# SERVICE BULLETIN

**SB-030223-A**

**ID NUMBER & REVISION:** SB-030223-A  
**SUBJECT:** CPS Wire Chafing  
**RELEASE DATE:** 31 March 2023  
**EFFECTIVE DATE:** 31 March 2023  
**SUPERSEDES NOTICE:** N/A  
**AIRCRAFT AFFECTED:** **MAKE & MODEL:** A5  
**SERIAL NUMBERS:** 00001 – 00136, 00139 – 00146, 00148 – 00150, 00152 – 00159, 00161, 00163, 00166  
**REQUIRED ACTION:** Inspect the CPS wires for any chafing and secure the CPS wires to the knock sensor bracket.  
**TIME OF COMPLIANCE:** At the next service interval.  
**REVISION HISTORY:** A Initial Release

Figure 1 CPS Wire Location

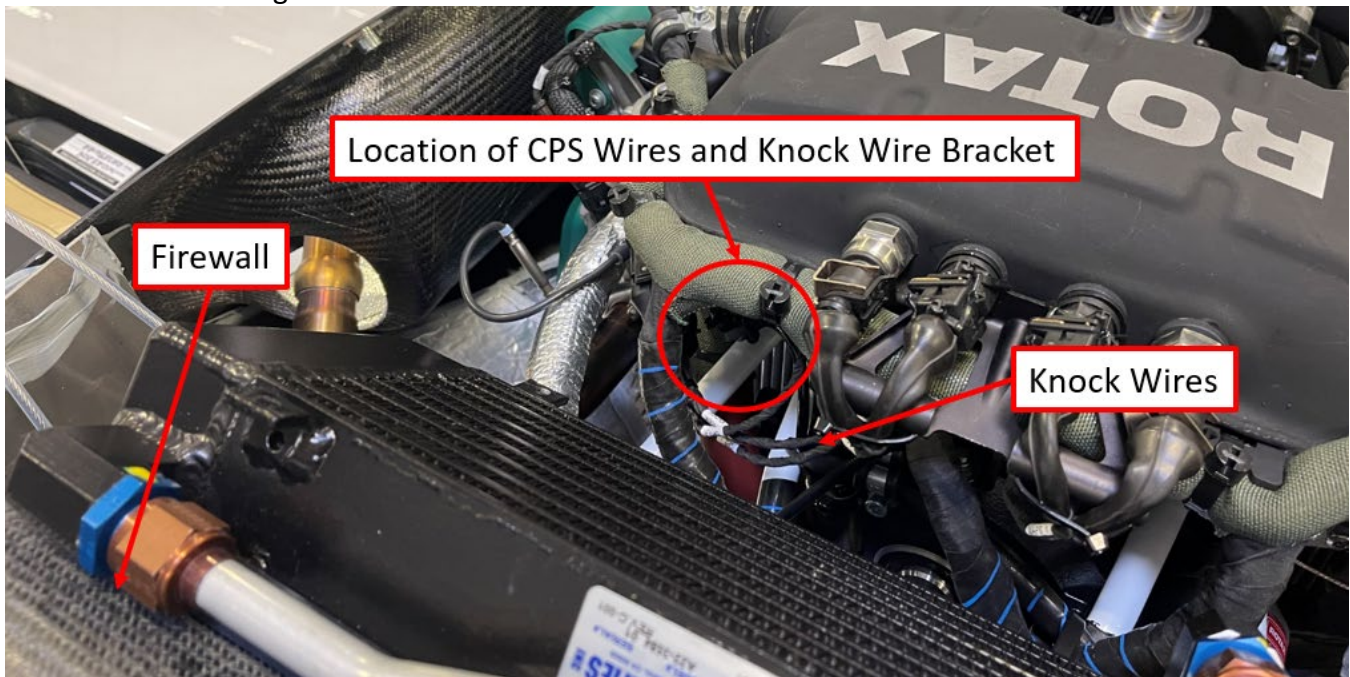
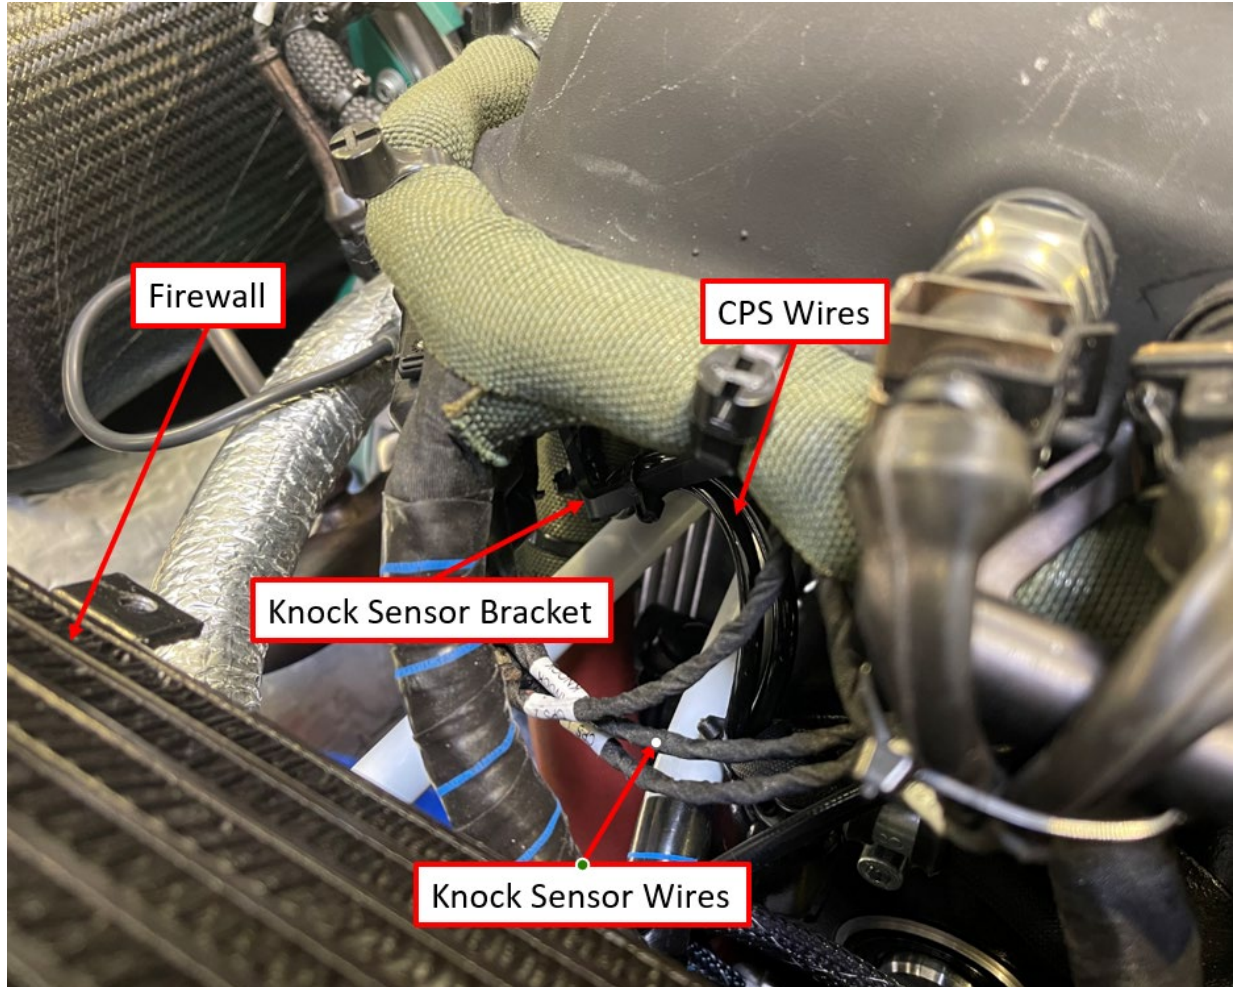
2. Locate the CPS wires, near the Knock Wire Bracket, on the front of the engine.
  - a. See Figures 1 and 2.
3. Identify any evidence of wire chafing.
  - a. See Figure 7.
4. If there is no evidence of wire chafing, then:
  - a. Proceed to the “Repair” section of this Service Bulletin.
5. If there is evidence of wire chafing, but no wires are exposed through the insulation then:
  - a. Wrap the chafed area with F4 tape.
  - b. Proceed to the “Repair” section of this Service Bulletin
  - c. See Figure 7.
6. If there is evidence of wires exposed through the insulation, contact ICON Aircraft Service for further repair instructions.
  - a. Do not proceed to the “Repair” section of this Service Bulletin

1. Locate the CPS wires at the front of the engine, closest to the firewall.
  - a. See Figures 1 and 2

*Figure 3 CPS Wire Routing*

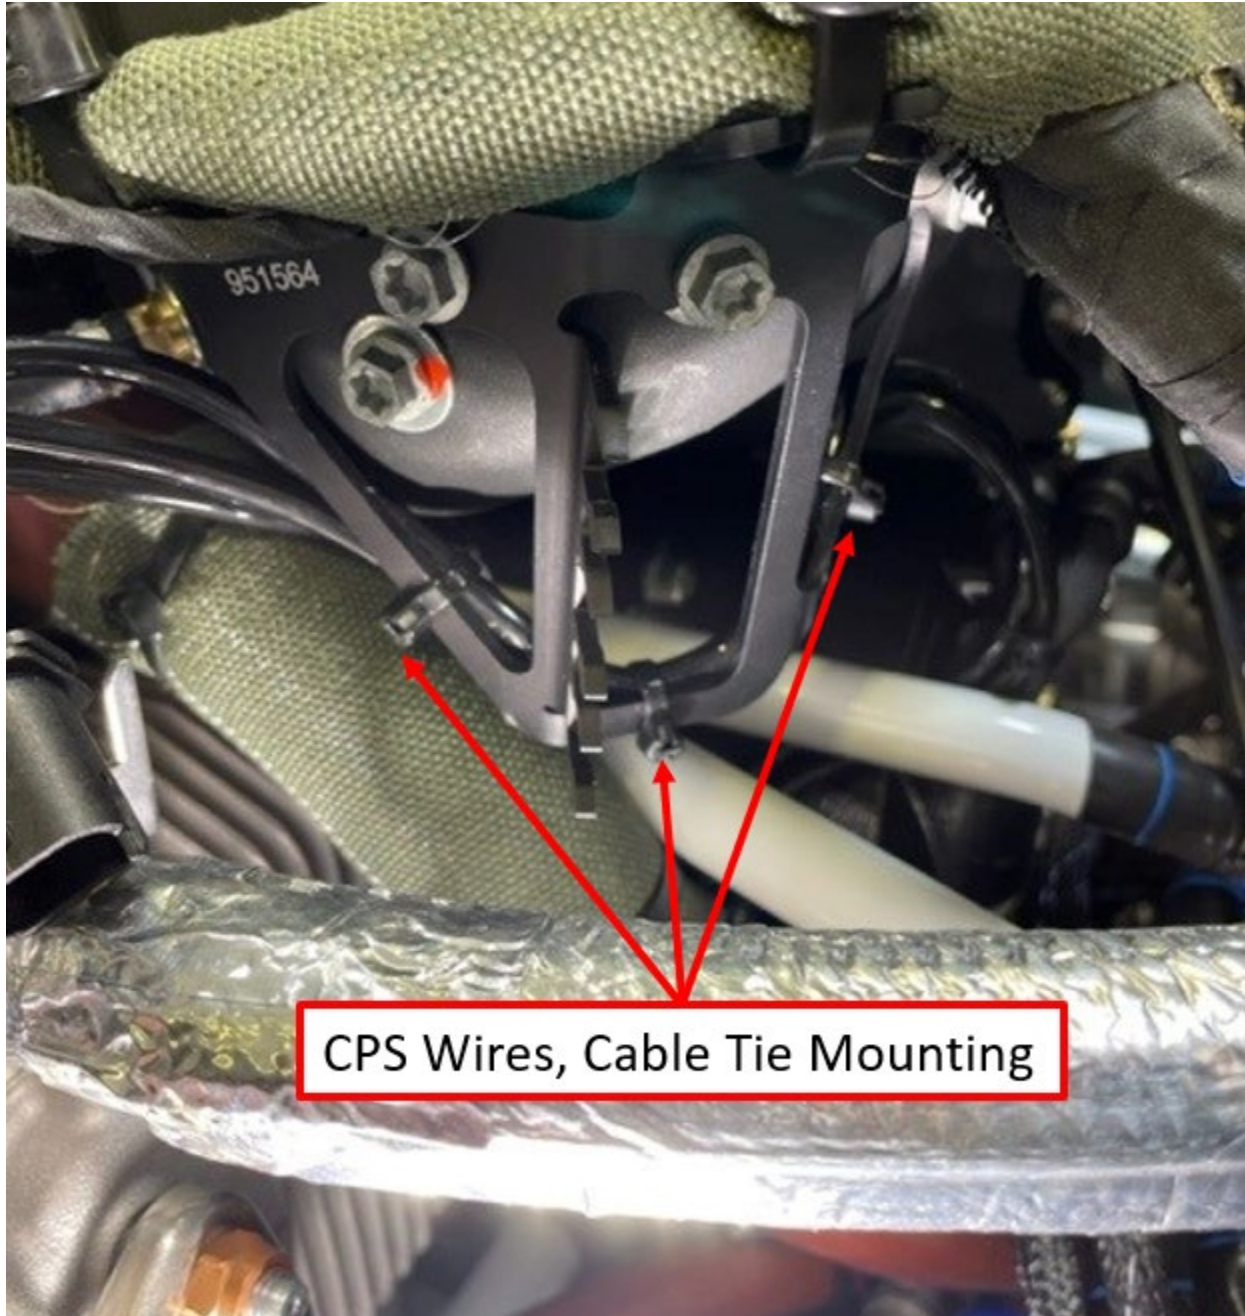
2. Follow the CPS wires towards the back and below the engine until the Knock Sensor Bracket.
3. Reposition the CPS wires away from the Knock Sensor wires, over the engine mount tube and on the inside of the Knock Sensor Bracket.
  - a. See Figure 3.

*Figure 4 CPS Wire Mounting*

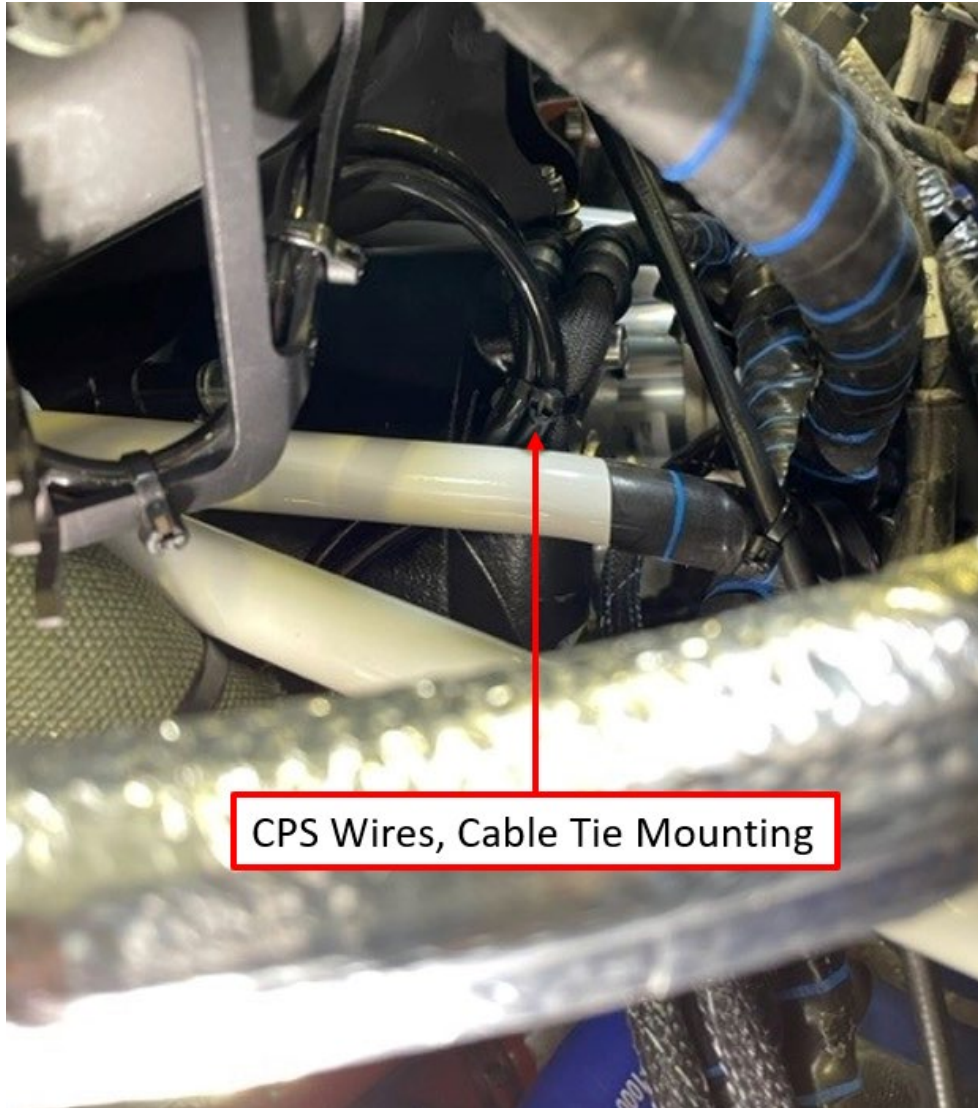
4. Secure the CPS wires to the inside of the Knock Sensor bracket with three Cable Ties
  - a. See Figure 4

*Figure 5 CPS Wire Mounting*

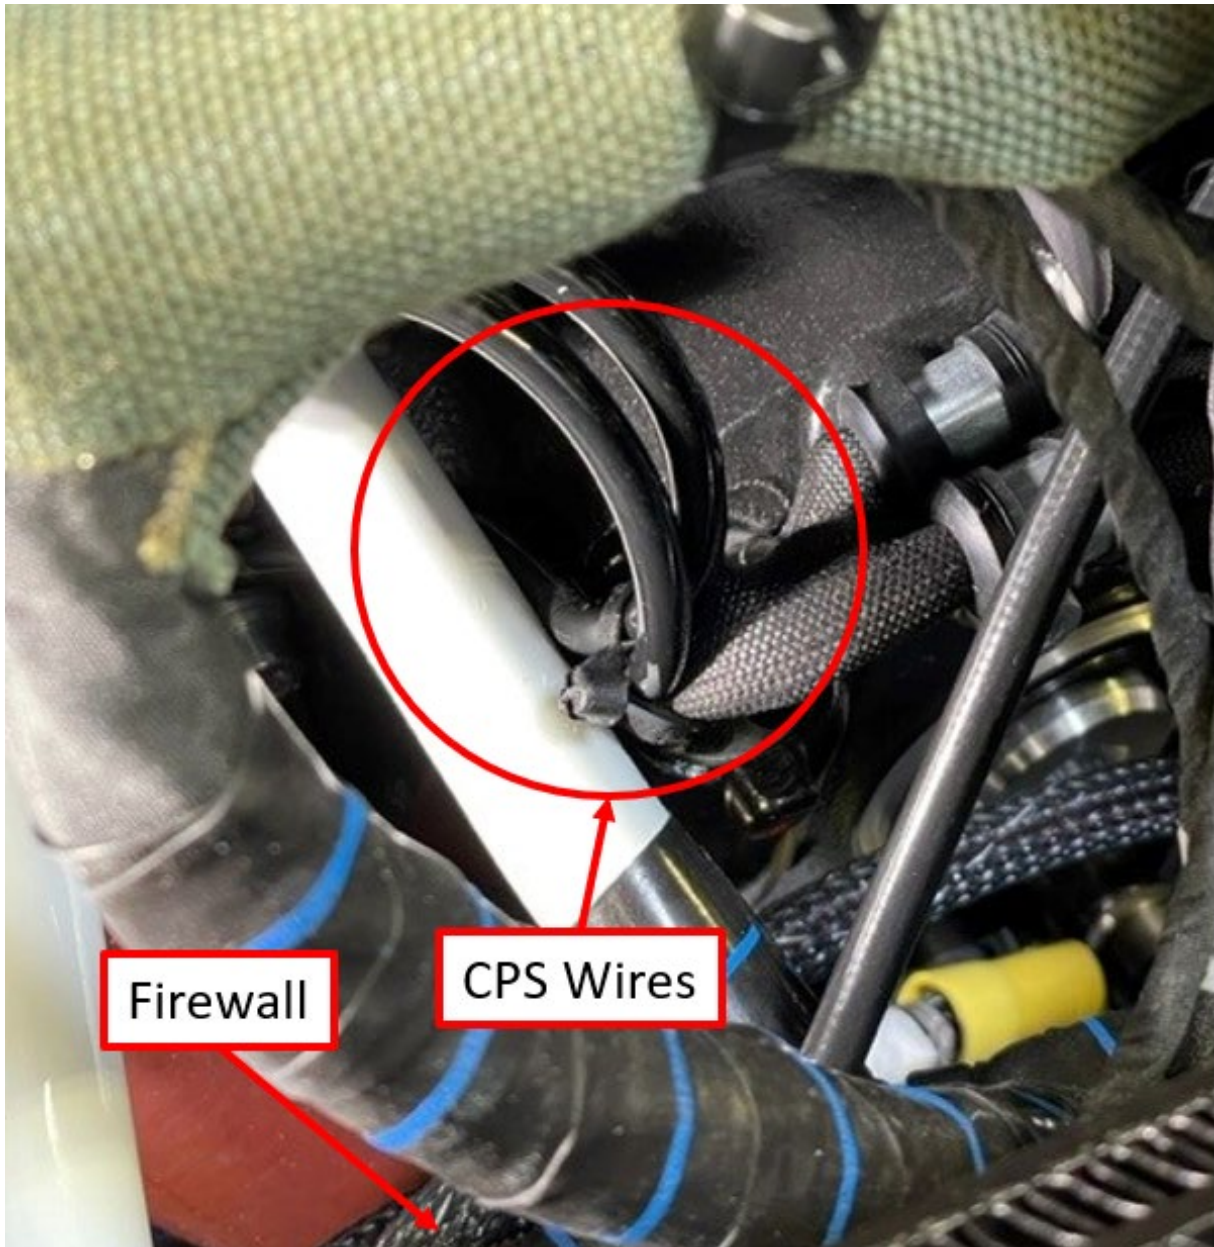
5. Secure the CPS wires to the wire harness before the Knock Sensor bracket on the inside of the engine mount tube.
  - a. Use one Cable Tie.
  - b. See Figures 5 and 6.
